**HISTORIC PRESERVATION BOARD
REVISED APPLICATION**

05/14/2024

PREPARED BY:
**JAMES
CORNER
FIELD
OPERATIONS**

LINCOLN ROAD DISTRICT IMPROVEMENTS PHASE 3

LINCOLN ROAD- 400 BLOCK
PAVING REVISIONS

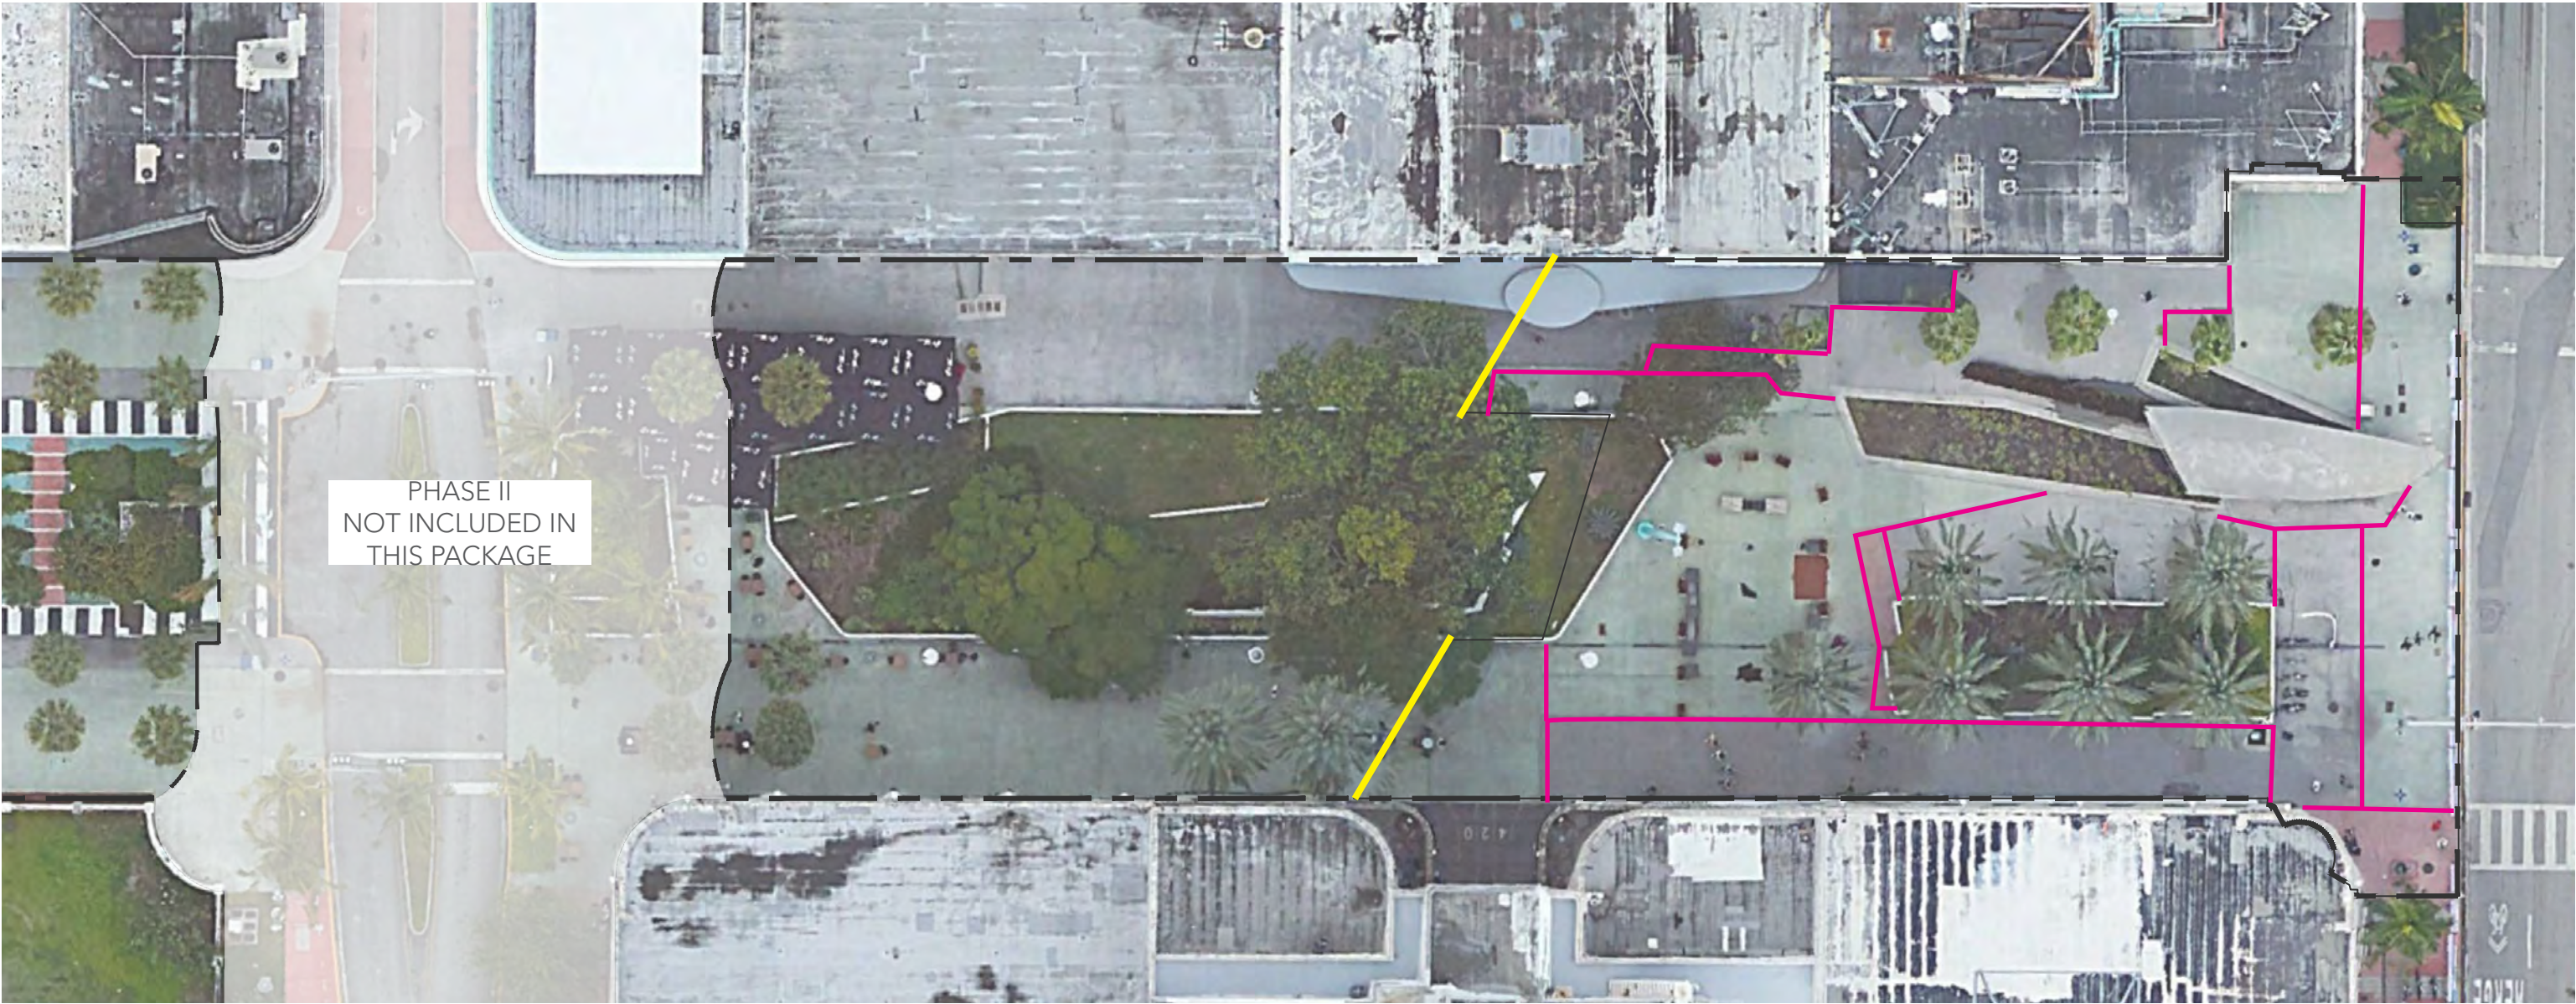
PAVING- REVISIT TRANSITION BETWEEN EXISTING GREEN PAVING TO REMAIN AND PROPOSED NEW PINK PAVING

REVISED PLAN 05/14/2024

- 1 EXISTING COLORED CIP CONCRETE TO REMAIN
- 2 PROPOSED PINK COLORED CIP CONCRETE
- 3 PROPOSED BLACK AND WHITE PRECAST CONCRETE PAVERS

LINCOLN ROAD- 400 BLOCK
REVISED FURNISHING APPROACH (05/14/2024)

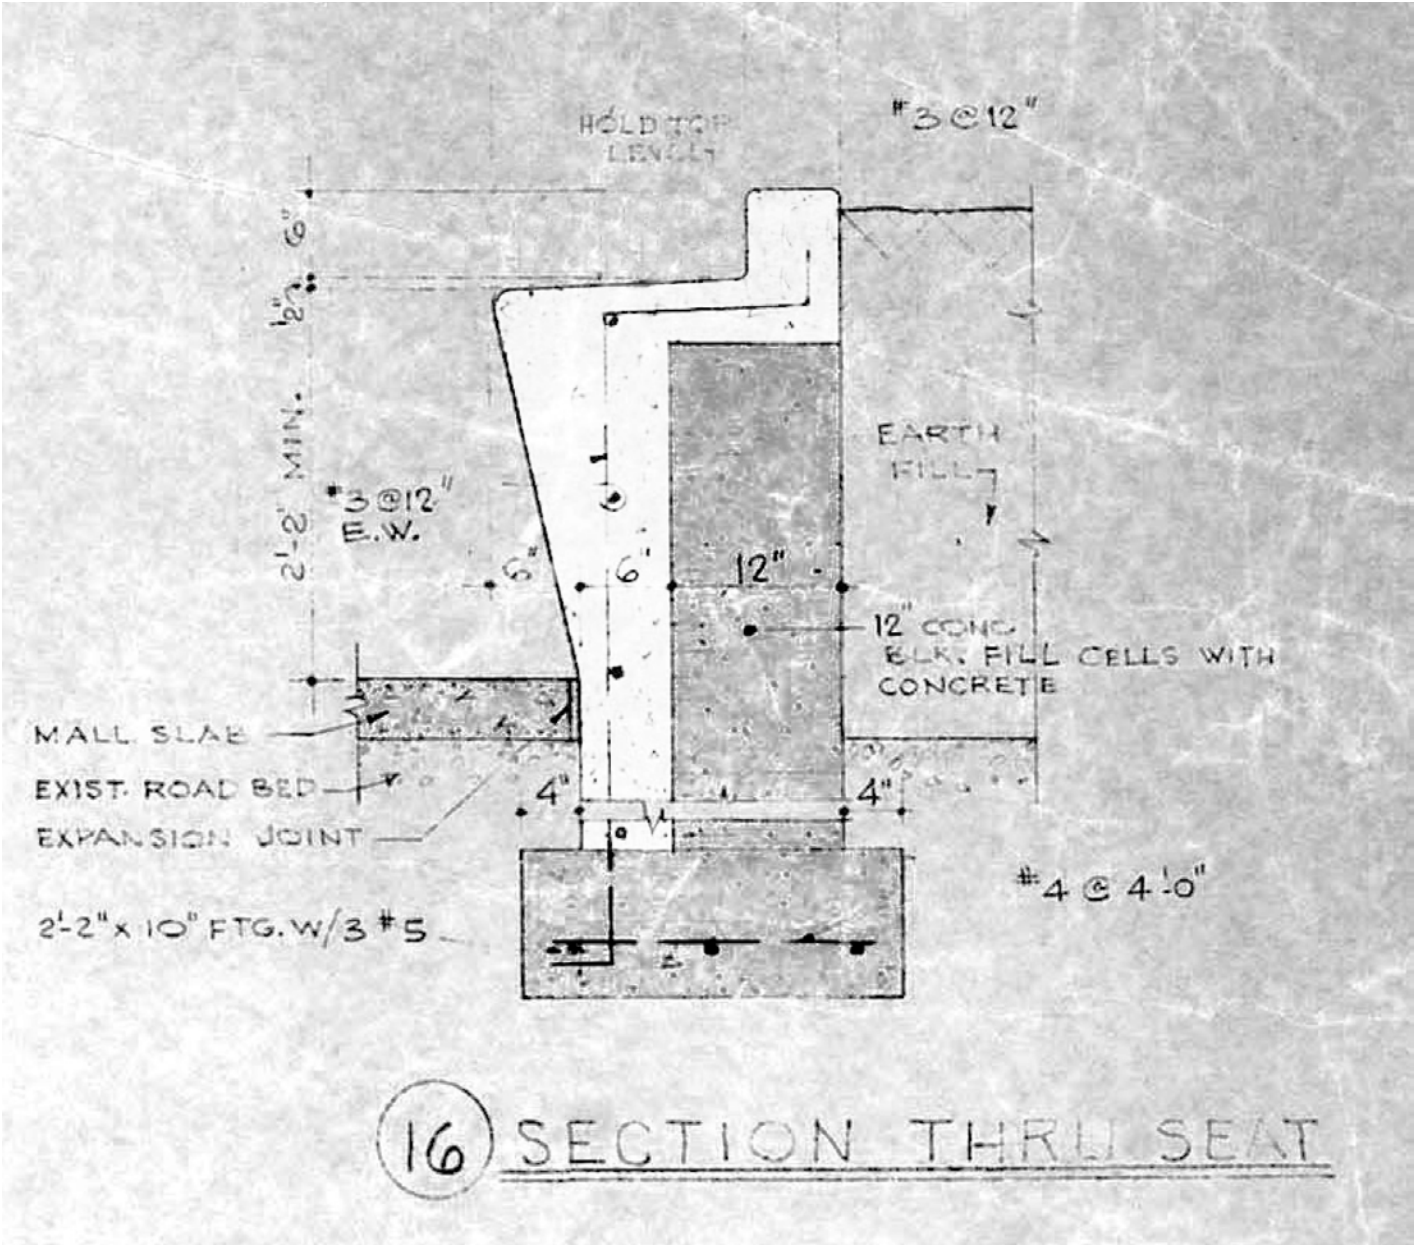
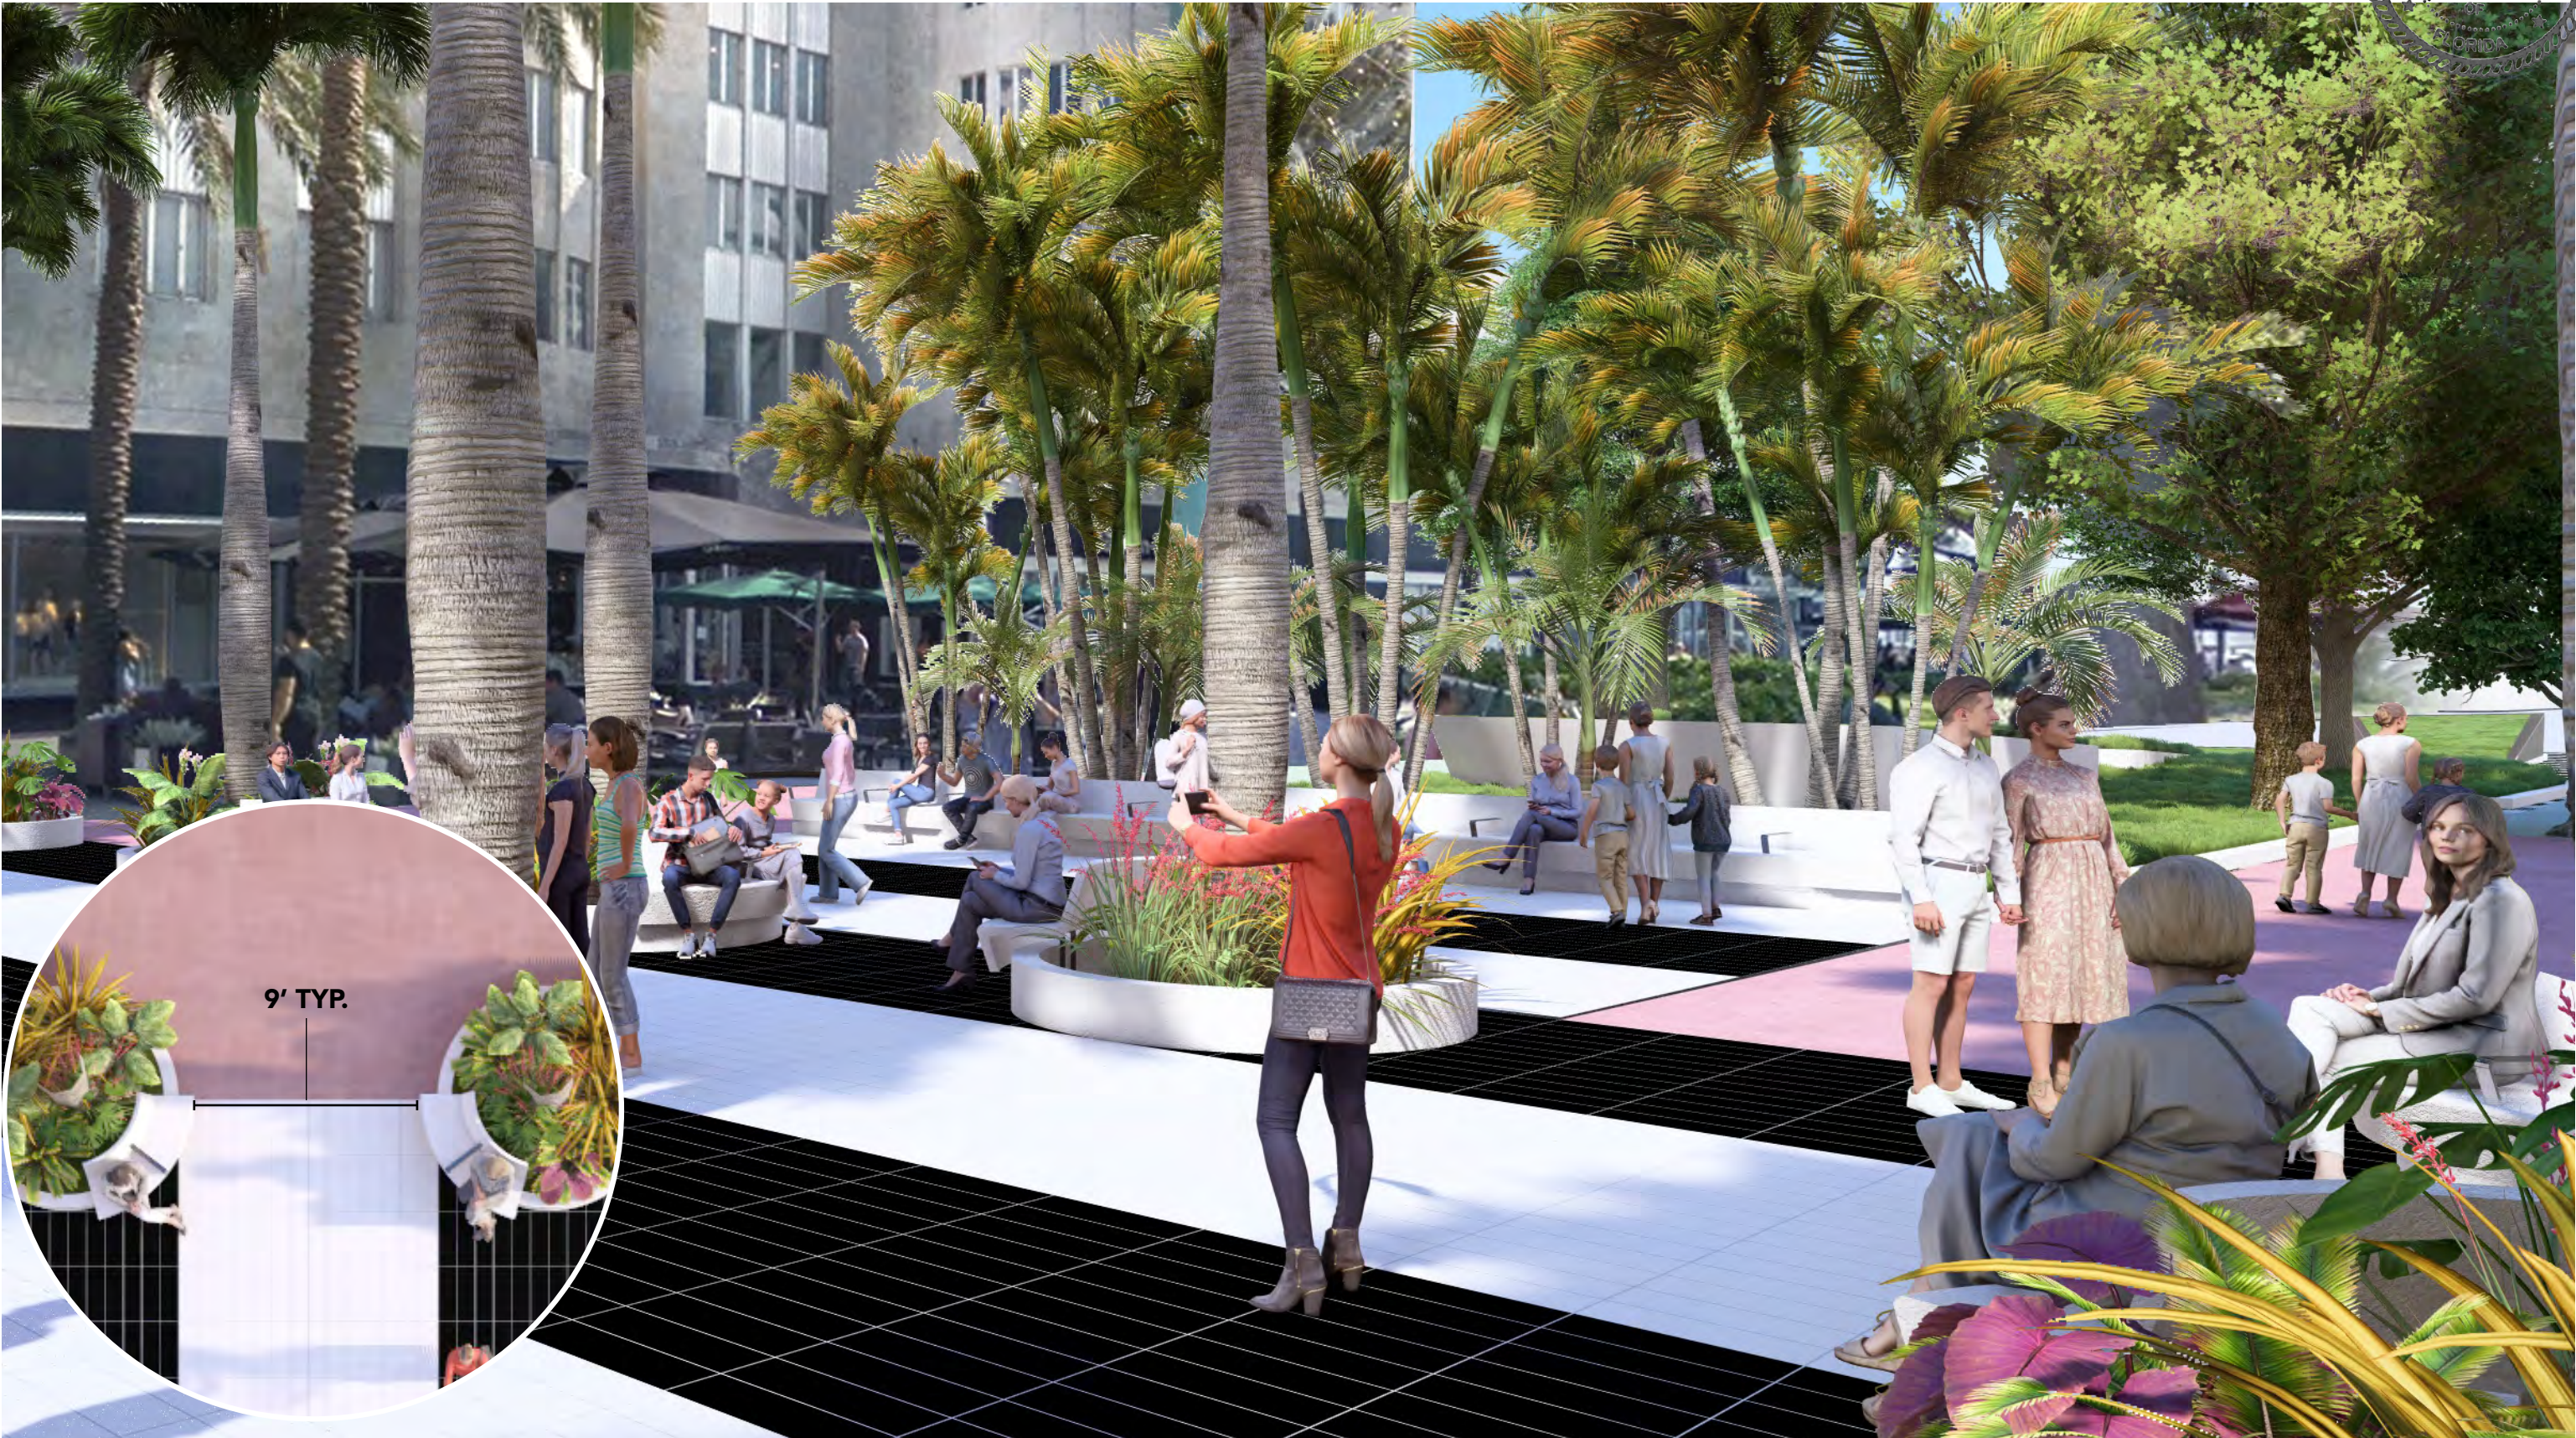
SEATING- PROPOSE ALTERNATIVE TO MOVEABLE SEATING
